MEMORANDUM

RE: **Transportation Review of Alternatives**

Nelson\Nygaard was retained to examine the preliminary multimodal transportation operations and impacts of several proposed site development concepts for the West Rosslyn project. This memo captures our initial analysis of the proposed concepts and their operational performance and impacts.

Figure 8 Alternative 1 - Pierce Street Two Way

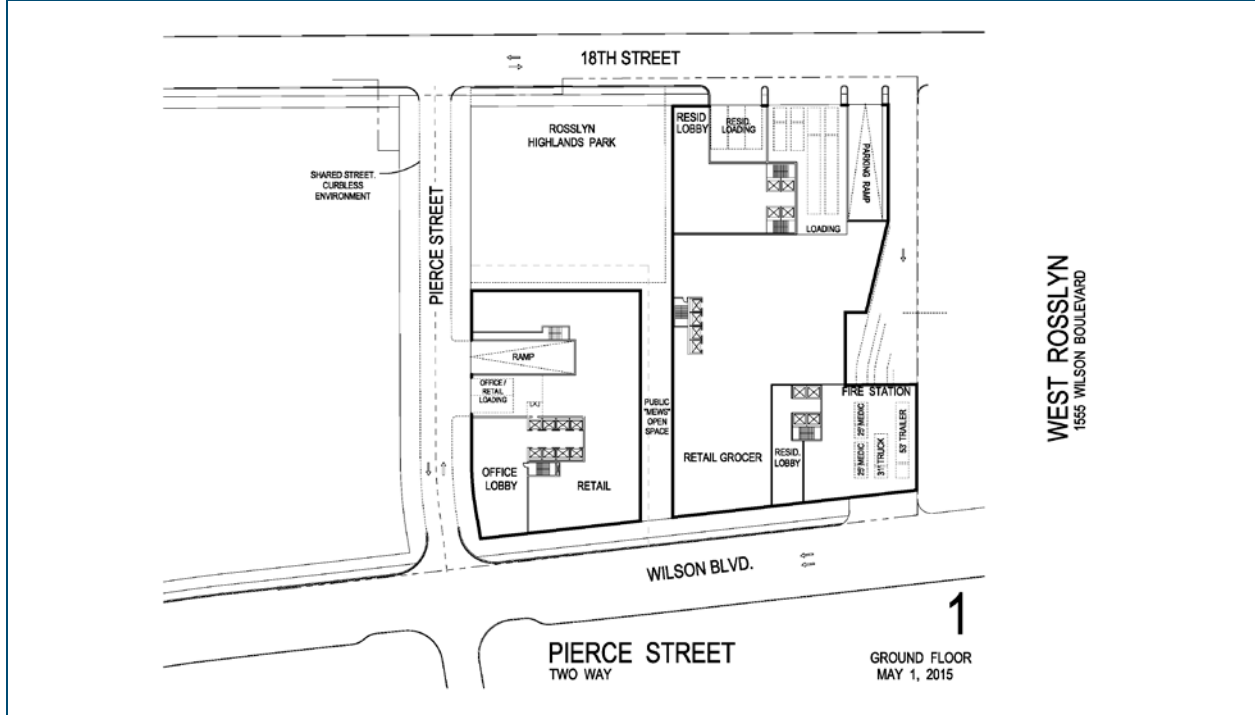
Alternative 1 provides good access and egress from all points and provides the opportunity for an even distribution of traffic (Figure 9). The aligned Pierce Street extended provides a signalized juncture with Wilson Boulevard and direct access to Clarendon Boulevard.

Access to the grocer parking facility is fairly intuitive *after full construction* however, Pierce Street extended could not be provided until the latter phase of the project, potentially some years after delivery of the first building. This significantly complicates access and circulation issues to the site. All trips would be concentrated on 18th Street with a significant majority traversing Oak Street. Residents, patrons and visitors arriving from the west would be the most challenged.

Loading will occur along the same access/egress routes as autos. Given the narrow width of 18th Street, curbside parking must be restricted along both the north and south sides of the street in the vicinity of loading bay. Loading is back-in from 18th Street. This may cause significant delays and disruptions to multimodal travel along 18th Street while trucks, especially the larger vehicles, are maneuvering into the loading bays.

Having a signal at the Pierce Street access/egress point will generally hold traffic at a designated stop bar maintaining clear pedestrian crossing along the heavily traveled Wilson Boulevard sidewalk. Further, the single access point minimized intrusion of vehicles across the pedestrian path of travel. A sizable extent of curb cuts accessing the retail and residential loading facilities and parking access for the garage facility somewhat diminishes the pedestrian realm of 18th Street but can be managed if sensitively designed.

Alternative 1 provides the Pierce Street extended as envisioned in the preferred Arlington Public Schools (APS) drop off option. However, access to the loading dock becomes more difficult during the AM arrival and PM dismissal school periods when school buses are aligned along the western curb edge and functionality of this access may be compromised. Furthermore, as previously mentioned, the inability to deliver this street during the first phase of construction introduces additional conflicts as a higher concentration of truck and passenger vehicle traffic will use the Quinn Street and 18th Street segments adjacent to the housing and school sites.

At full build out, Alternative 1 provides benefits in terms of access and integration with the pedestrian realm, HOWEVER the necessary phasing of the project, introduces substantial complications in access and loading that make this a less desirable alternative. Loading access to the office building off of Pierce Street extended may be compromised while school buses are present. The loading maneuvers for larger vehicles on 18th Street cannot be accommodated within the existing cartway of 18th Street likely rendering this alternative infeasible.

Figure 10 Alternative 2 - Ode Street Two-Way

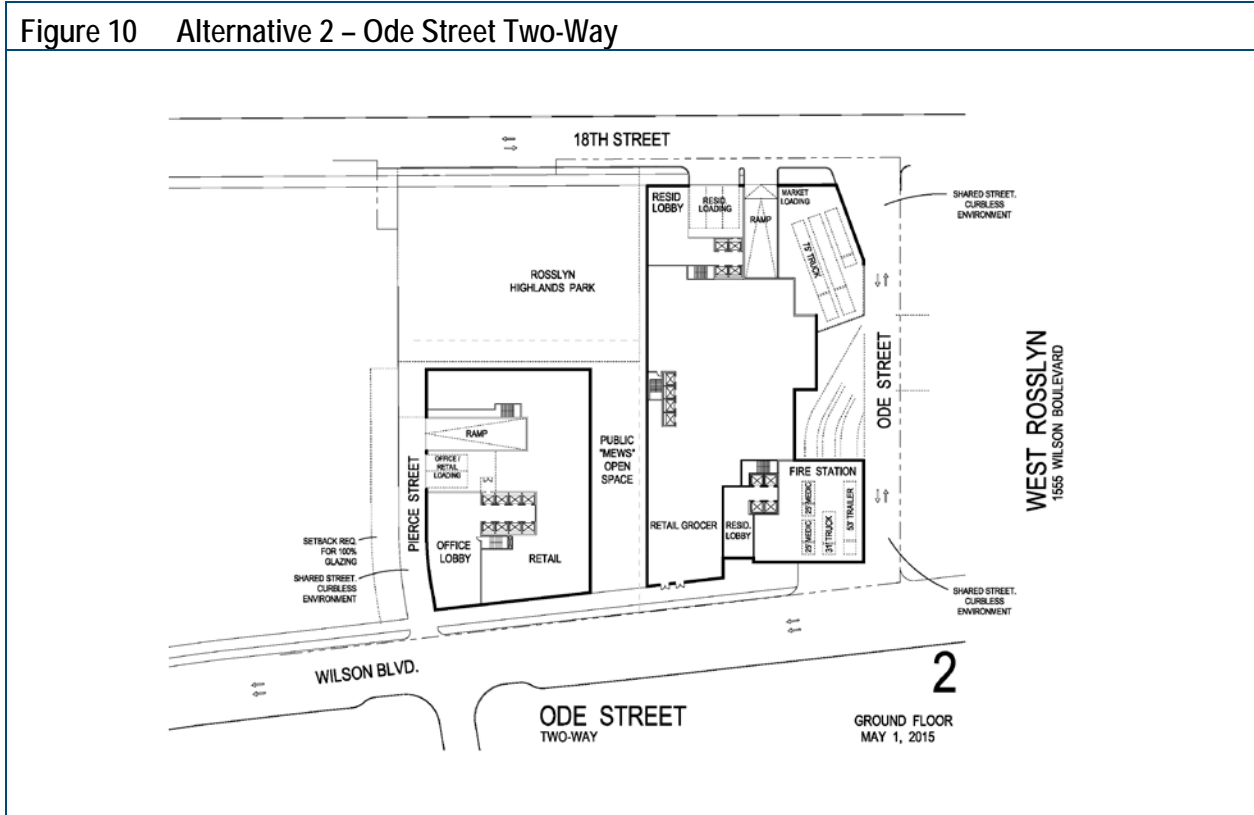
Alternative 2 would enable the establishment of N. Ode Street during the first phase of construction – an important consideration. This provides good and logical access to the grocer and large residential property right from the onset of occupancy. Vehicle access is relatively evenly distributed between N. Quinn, N. Oak/Nash and Wilson Boulevard. Residents, patrons and visitors accessing the site from the west along Clarendon Boulevard would need to make a small amount of circuitous travel, bypassing Pierce to access from N. Oak Street, as they must do to access the site today.

Loading for the retail will be back-in loading from the new Ode Street. This angled loading is maneuverable for all sizes of vehicles. Back in access should be able to occur expeditiously, though there is the potential for conflict between the grocery loading and fire department operations. Loading for the residential building will be back-in loading from 18th Street.

Alternative 2 includes two curb cuts off of Wilson Boulevard and a series of curb cuts along the south side of 18th Street N. The woonerf design of N. Ode Street will create a convenient multimodal link with the north-south courtyard creating alternate pedestrian-only connections between Wilson Boulevard and 18th Street.

Alternative 2 does not provide the Pierce Street extended as envisioned in the preferred Arlington Public Schools (APS) drop off option and therefore this alternative is not possible. However, a long, uninterrupted block face is provided along 18th Street between N. Quinn Street and the proposed Ode Street. This relatively quiet street provides a safe and attractive location for bus drop off. Buses may circulate and egress the area via the new Ode Street which provides a safe merge point back onto Wilson Boulevard (or they may continue east on 18th Street). Parent drop off can be accommodated along 18th Street without incident.

Overall, Alternative 2 provides a number of appealing features that make it a very viable alternative for further refinement, modeling and consideration. Loading from Ode Street reduces the curb cuts along 18th Street and minimized disruptions to that street. School drop off is easily accommodated along the 18th Street school and park frontage area and school bus circulation is efficient.

Figure 14 Alternative 3b – New Street Midblock Two-Way

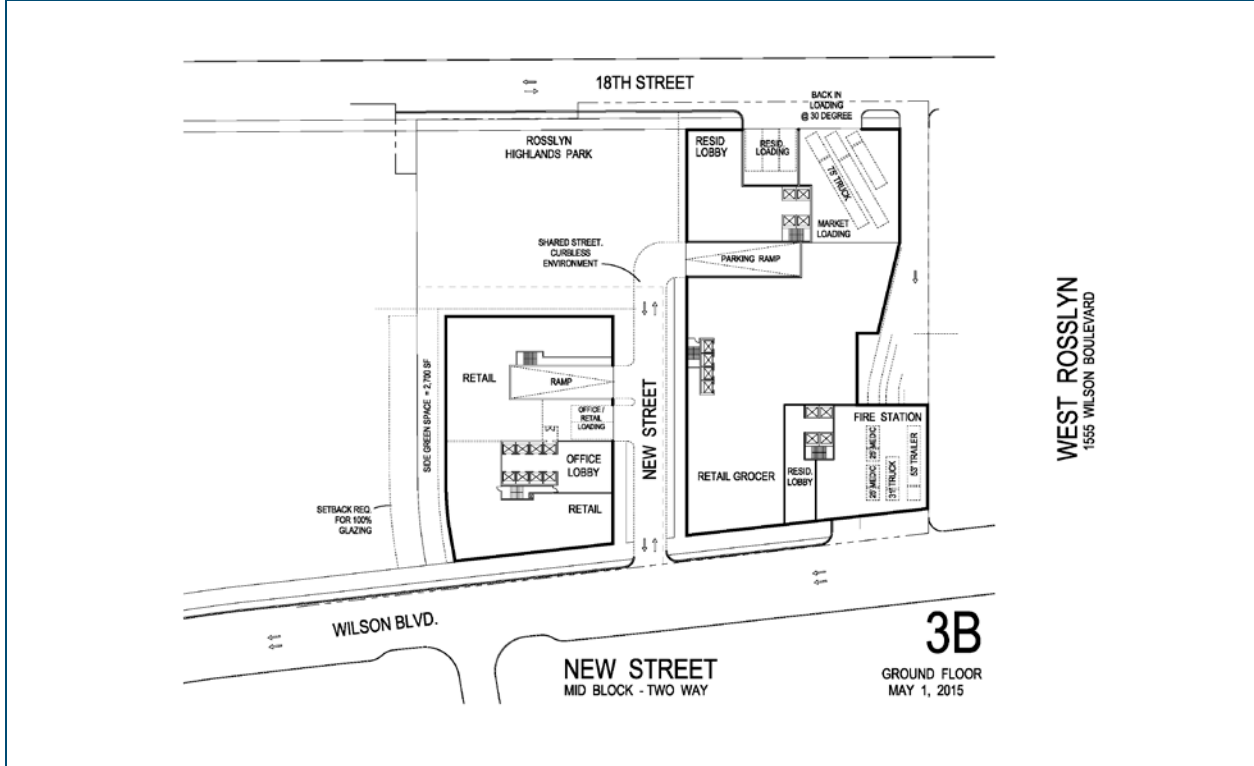
Alternative 3b requires that all traffic, except loading vehicles servicing the retail/residential building access the property utilizing the segment of Wilson Boulevard between N. Oak and N. Pierce Street and that all traffic egress the property at an unsignalized location on Wilson Boulevard (Figure 15). This concentrates the vast majority of traffic onto Wilson Boulevard and does not permit a dispersal of trips throughout the available network. This raises significant concerns about potential queuing issues as vehicles access the site and queuing on New Street as vehicles attempt to egress during the peak hours. Given the proximity to the existing Pierce Street, vehicle egressing from the project may attempt to weave over to continue on southbound Pierce and onto eastbound Clarendon. The platooning effect from the upstream signals, combined with the 25MPH speed limit and minimal westbound queuing, however, provides adequate gaps in traffic to accommodate the weaving maneuver. Nonetheless, efforts should be made to reduce the number of drivers exercising this option.

Loading for the retail/residential building will be back-in angled loading from 18th Street. Loading for the office building will have back-in accessed from the proposed New Street . Trucks may access the grocer via the existing Oak Street. Trucks servicing the office building must arrive and depart via Wilson Boulevard. As with alternative 3a, trucks maneuvering into the loading bays off 18th Street may cause minor disruption in that corridor operations and pedestrian experience.

Although Alternative 3b includes only one curbcut on Wilson Boulevard, it is at an unsignalized location. This raises concern of the high likelihood that vehicles waiting for a gap in traffic to egress from New Street

onto Wilson Boulevard will block the Wilson Boulevard sidewalk pathway forcing pedestrians into the street or around waiting vehicles. This is particularly hazardous for pedestrians with mobility challenges such as seniors or those in strollers, wheelchairs or other mobility assistance devices.

From a traffic and transportation perspective, Alternative 3b is considered the worst case scenario and the one most likely to lead to concentrations of traffic, potential queuing issues, and uninviting and potentially hazardous pedestrian conditions.

Figure 15 Alternative 3b – Access and Egress

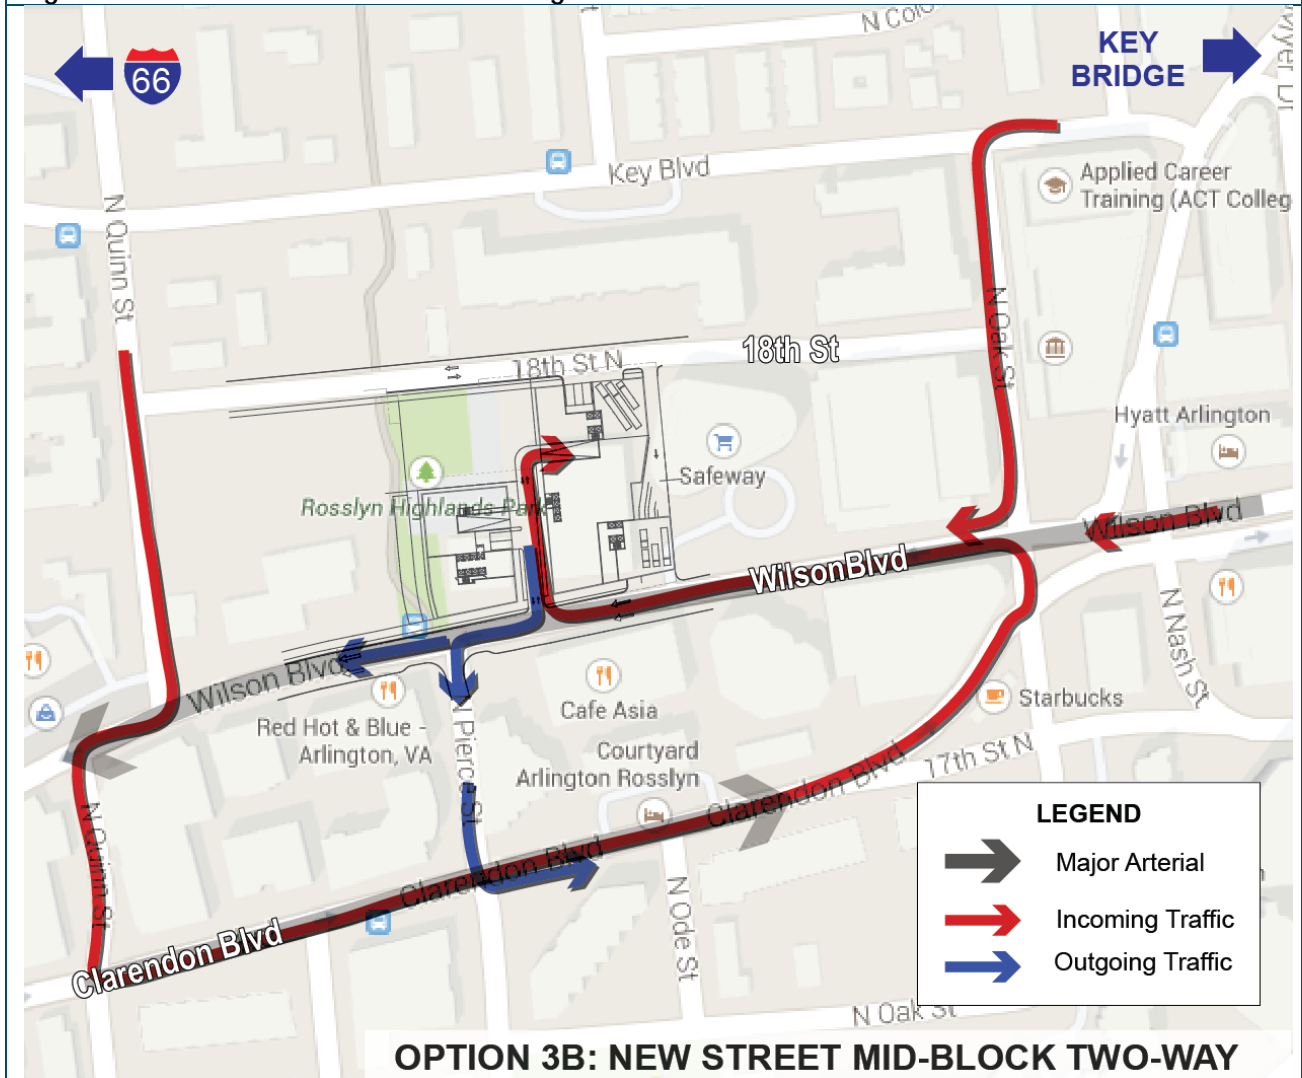
One advantage is that access for grocery patrons is clear and direct via the parking ramp access that will be clearly visible and logically accessed from the proposed New Street .

Figure 16 Alternative 3c – New Street Midblock Two-Way

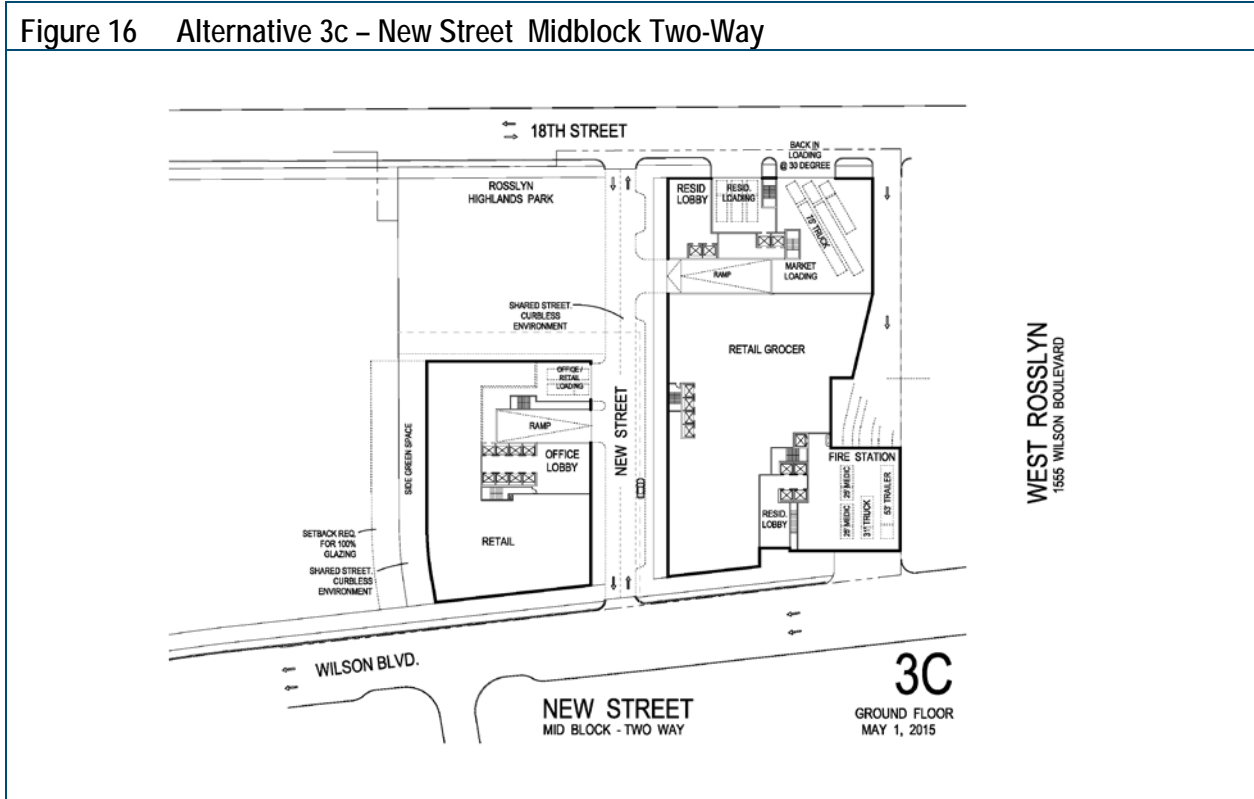
Alternative 3c, with through two-way operations of New Street provides similar alternatives for accessing the site as in 3a. The primary difference is the office parking ramp and loading being accessed from New Street. The site plan provides clear access for grocery patrons and minimizes curb cuts along Wilson Boulevard.

Loading for the retail/residential building will be back-in angled loading from 18th Street. Loading for the office building will have back-in accessed from the New Street. Trucks may access the grocer via the existing Oak Street. Large trucks may cause some delay on 18th Street as they maneuver into bays. Trucks servicing the office building can arrive and depart via either 18th Street or Wilson Boulevard.

Alternative 3c's New Street will consistently provide safe and inviting through-pedestrian access between Wilson Boulevard and 18th Street. The quality of the walk environment may not be ideal given the number of curb cuts along the street and the concentration of vehicles anticipated. However, as in Alternative 3b, an alternate pedestrian connection is provided to the west of the proposed office building in the second phase of development which provides another route for access.

Overall, Alternative 3c provides a viable alternative for site development with balanced and even distribution of access and egress. Distinguished from 3a in that all parking traffic utilizes New Street, the site plan nonetheless offers a number of alternative means of access and circulation.

Figure 18 Alternative 4 – Ode Street Rotated Office Building

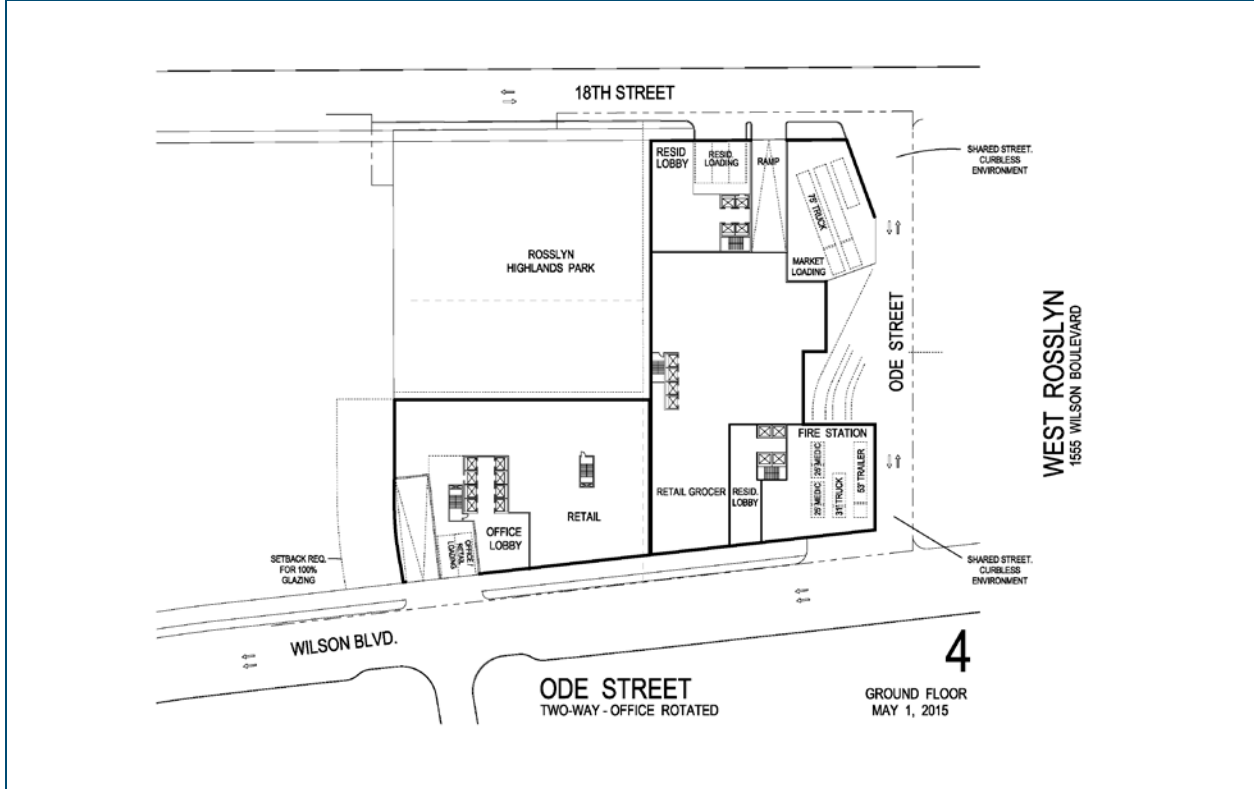
Loading is angled back-in from the new Ode Street for the proposed grocer. Loading for the residential element of the phase I building is back in from 18th Street as it is in other schemes. Loading for the office building is from Wilson Boulevard, however this too is conceived as back-in access. Office loading could be significant. Material delivery (paper goods and office supplies) will be fairly limited, however loading for the retail ground floor tenant and delivery by FedEx and other carriers can be quite frequent – up to 15 deliveries per day. The back-in loading maneuvers could cause significant hazards and disruptions on the corridor for both traffic and pedestrians.

Alternative 4 includes a significant curb cut on Wilson Boulevard which would cause a highly disruptive condition in the pedestrian environment on this highly used and valued pedestrian corridor. The back-in loading is a concern, again given the high pedestrian volumes. The introduction of an even higher concentration of youth pedestrians associated with the school heighten this concern.

Pedestrian connectivity through the site to the APAH property is least accommodated in this option. Pedestrians may traverse the park and mews between the school and office building parking lot or continue down to the new Ode Street.

While Alternative 4 could would operate reasonably well from an auto vehicle access perspective, the loading condition for the office building is not a recommended nor endorsed condition.

Figure 19 Alternative 4 – Access and Egress

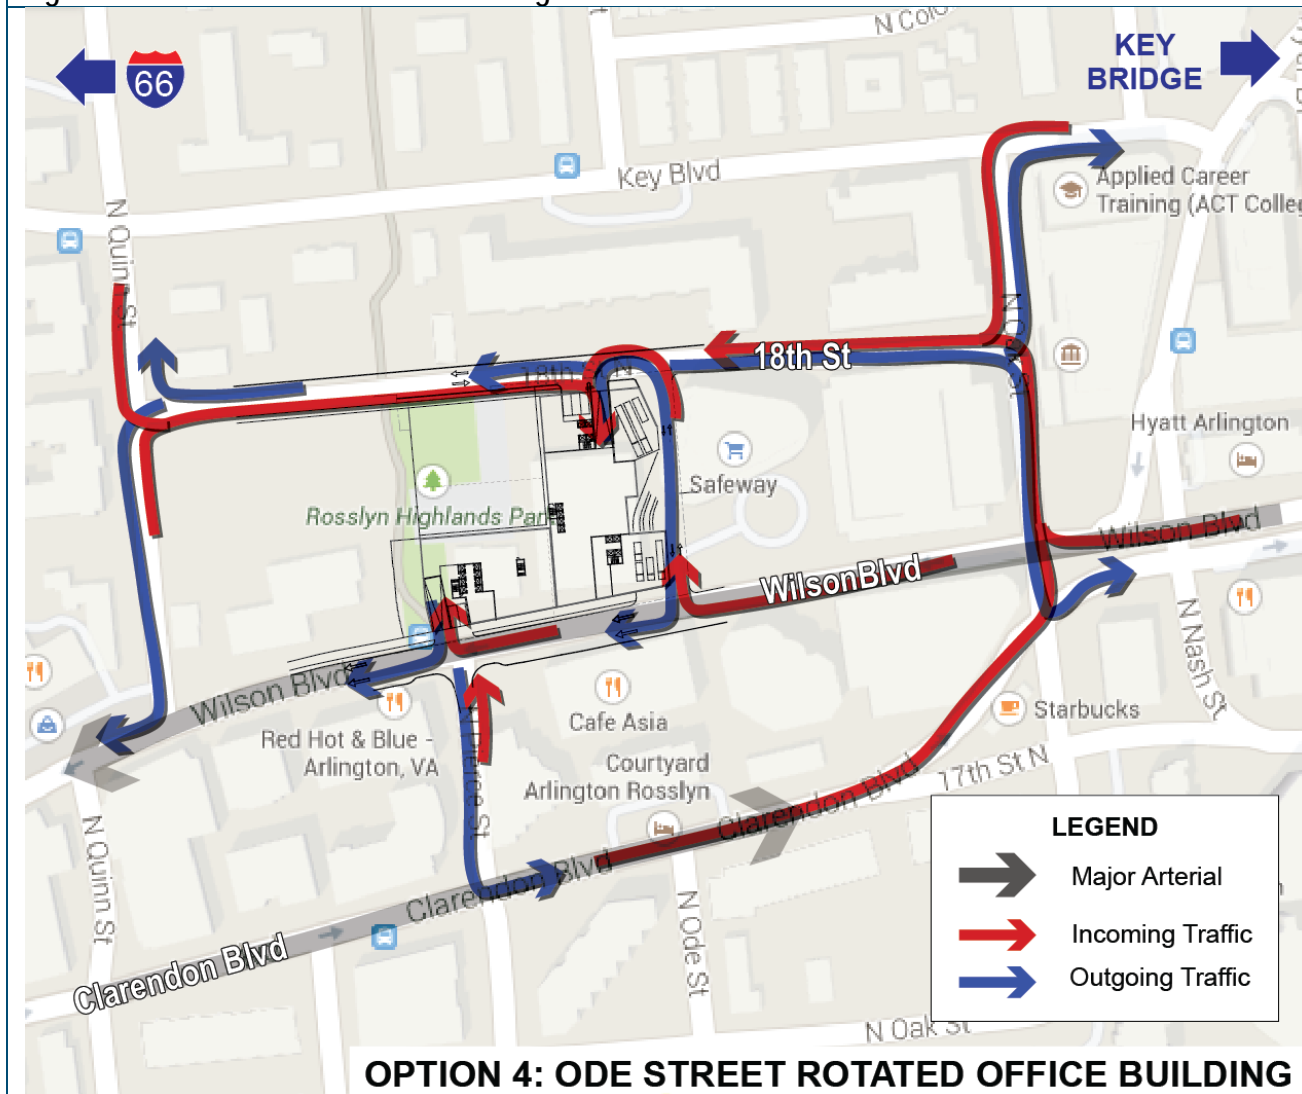
From the perspective of auto access to the building, Alternative 4 provides a number of different paths of access to the building and disperses traffic across the grid which eases concentrations of traffic at any one location in the network (Figure 19). The egress point of the new Ode Street provides enough separation from Pierce Street to enable additional for any vehicles wishing to progress onto southbound Pierce Street.
